UNITED STATES PATENT AND TRADEMARK OFFICE

APPLICATION NO.	FILING DATE	FIRST NAMED INVENTOR	ATTORNEY DOCKET NO.	CONFIRMATION NO.
10/671,086	09/25/2003	Charles W. Alvord	2003P88063 US	6320

Office Action Summary

DETAILED ACTION

Fig. 3
(PRIOR ART)

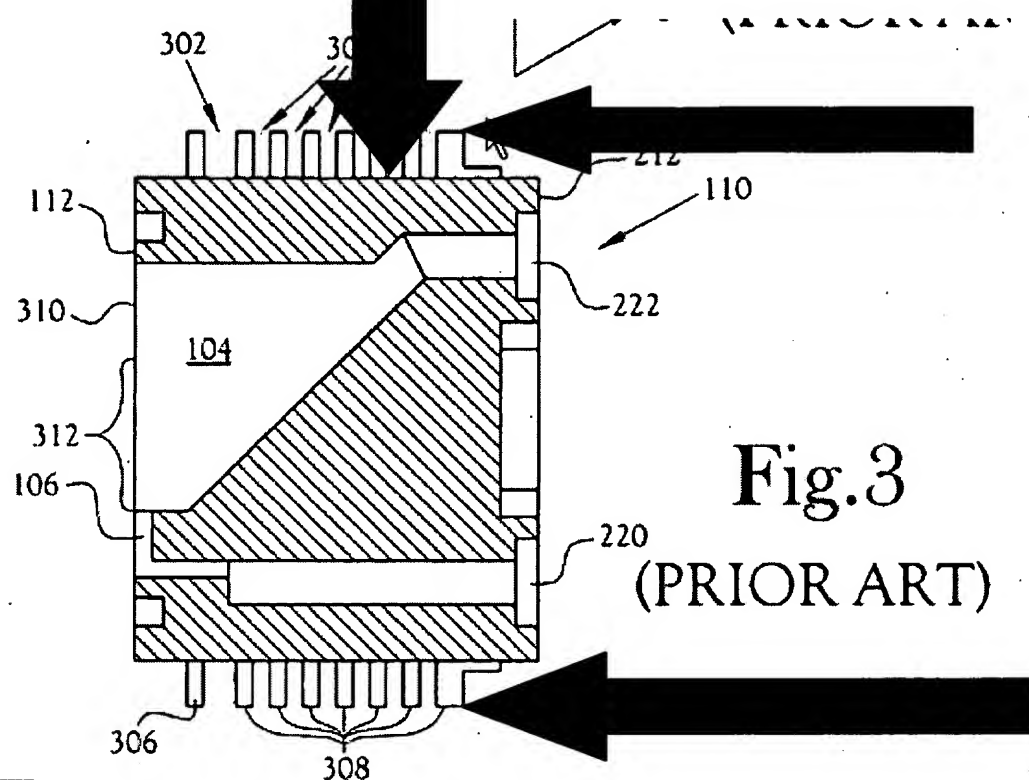
4. Regarding applicant's arguments (See page 9) against section 10 of said previous Office action, the limitation "within" is not considered as defining over the prior art as the cooling channels are indeed within the target body when the outer physical limits of the target body of the prior art are considered as the boundaries defining said target body. Resort may be had to the following figure as the arrow indicates the outer limits of the target body. Accordingly said channels (i.e. (302,304)) are indeed within said target body:

First, channels 302, 304 are within the circumference of the target body, accordingly the vertical arrow in Fig 3 above indicates a portion of the cooling channel running along a portion of the sloped rear wall.

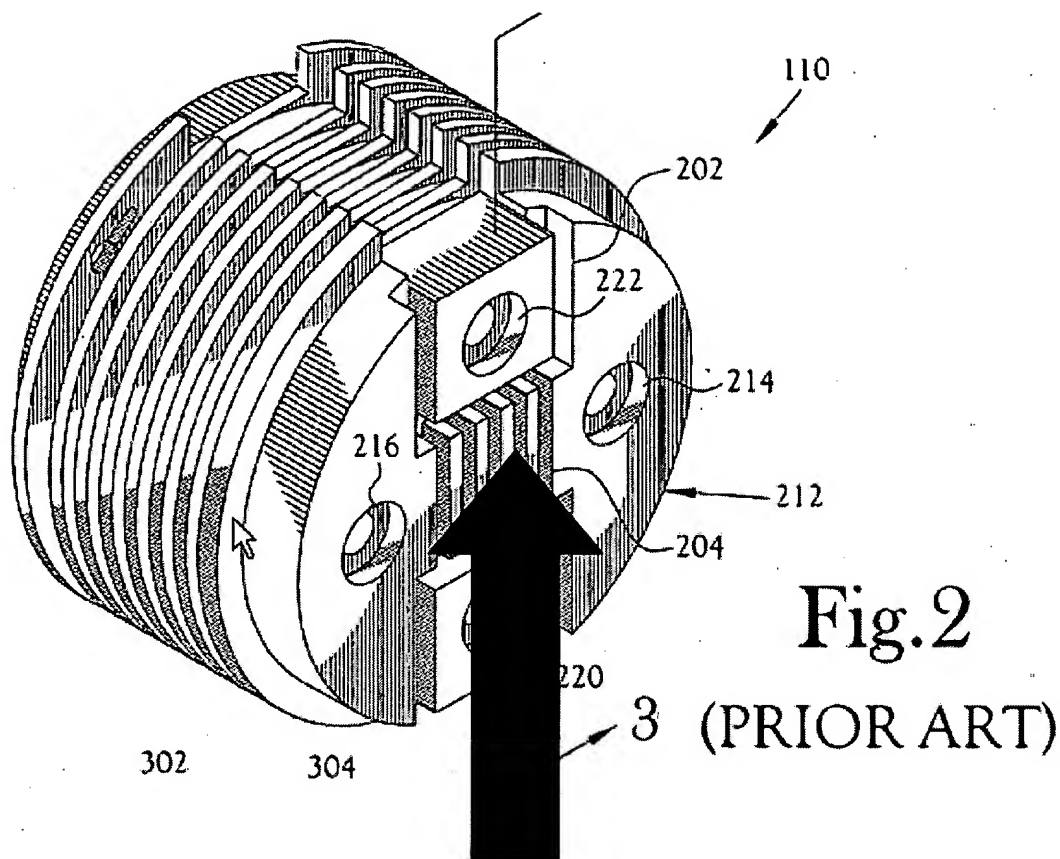
Second the back of the target also has cooling channels that run alongside a portion of the sloped rear wall as shown in Fig. 2 below.

Again, as previously expressed by the examiner, the cooling channels of the prior art run along at least a portion of the rear wall just as two lanes of a divided highway run along each other, since applicant has failed to set forth the metes and bounds of the limitations "running along at least a portion of said rear wall" the examiners assertions are correct.
